APPLICATION NO.	FILING DATE	FIRST NAMED INVENTOR	ATTORNEY DOCKET NO.	CONFIRMATION NO.
10/821,926	04/12/2004	Sheng-Hsiung Lin	2450-0666PUS1	2119
2292	7590	12/29/2004	EXAMINER	
BIRCH STEWART KOLASCH & BIRCH PO BOX 747 FALLS CHURCH, VA 22040-0747			SZUMNY, JONATHON A	
			ART UNIT	PAPER NUMBER
			3632

Office Action Summary

This is the first office action for application number 10/821,926, Angularly Adjustable Keyboard Support Bracket, filed on April 12, 2004.

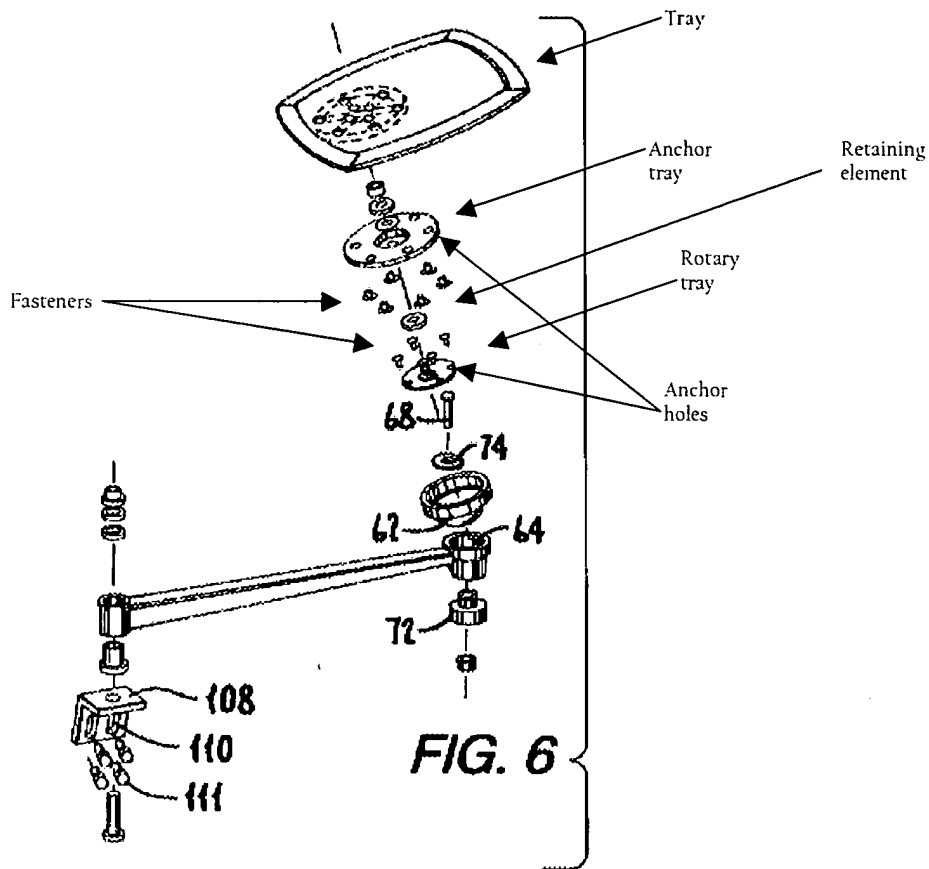
Claims 1, 2 and 4 are rejected under 35 U.S.C. 102(b) as being anticipated by U.S. Patent number 6,086,034 to McAllister et al.

McAllister et al. '034 discloses an angularly adjustable support bracket (figures 2-6) comprising a mounting rack (98) attached to a desktop, a movable arm (32) coupled with the mounting rack through a pin (102) and a bracing rack (38, generally) coupled on another end of the movable arm through another pin (106); wherein the bracing rack is extended to form a holding section (44, 62, 64) to hold a rotary mechanism therebetween such that a tray (above) is attached to the rotary mechanism, the rotary mechanism inherently would allow a tray to swivel to a left side and a right side to an angle relative to the bracing rack to provide users with a desired operating angle, wherein the rotary mechanism includes an anchor tray (above) fastened to the tray, a rotary tray (above) fastened to the holding section of the bracing rack and a

retaining element (above) located between the anchor tray and the rotary tray, wherein the anchor tray, the rotary tray and the retaining element having respectively an axle hole (see above) on a corresponding location to receive a bolt to engage with a nut (both the bolt and nut are functionally recited because of the phrases “to receive” and “to engage” and the axle holes could inherently receive a bolt to engage with a nut) , wherein the anchor tray and the rotary tray have respectively an anchor hole (above) that receives a fastening member (above) to run through the tray and holding section of the bracing rack.
